BENSALEM TOWNSHIP

Exhibit Z-4

Zoning Hearing Board

1160 Treeline Drive - A/L File No. 0907.0999.00

Edited drawing on 01/04/2015 in reference to items 1 and 2 from file # 0907.0999.00 dated October 7, 2014:

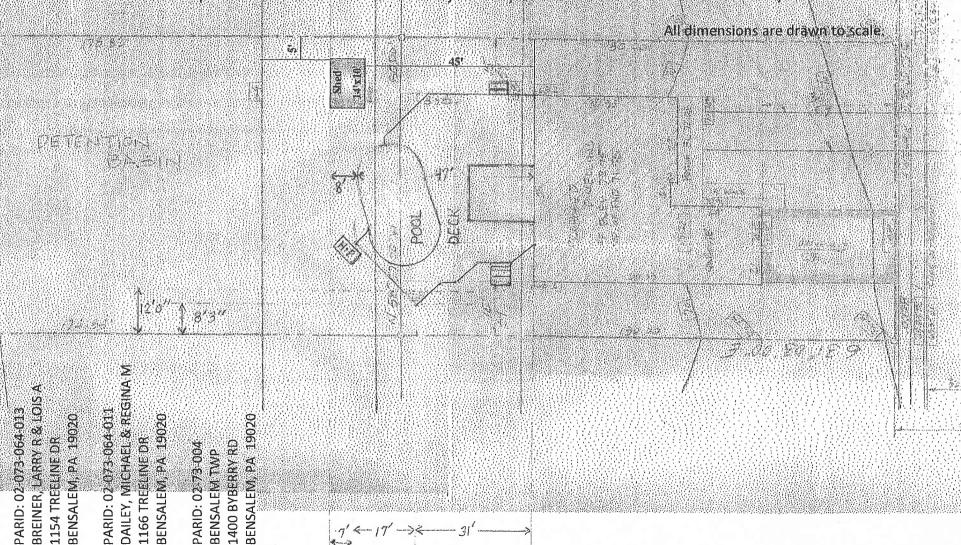
Variance requested for shaded area of the deck adjacent to plot location reference N 58° 57′ 00″ W by \$ 31° 03′ 00″ E.
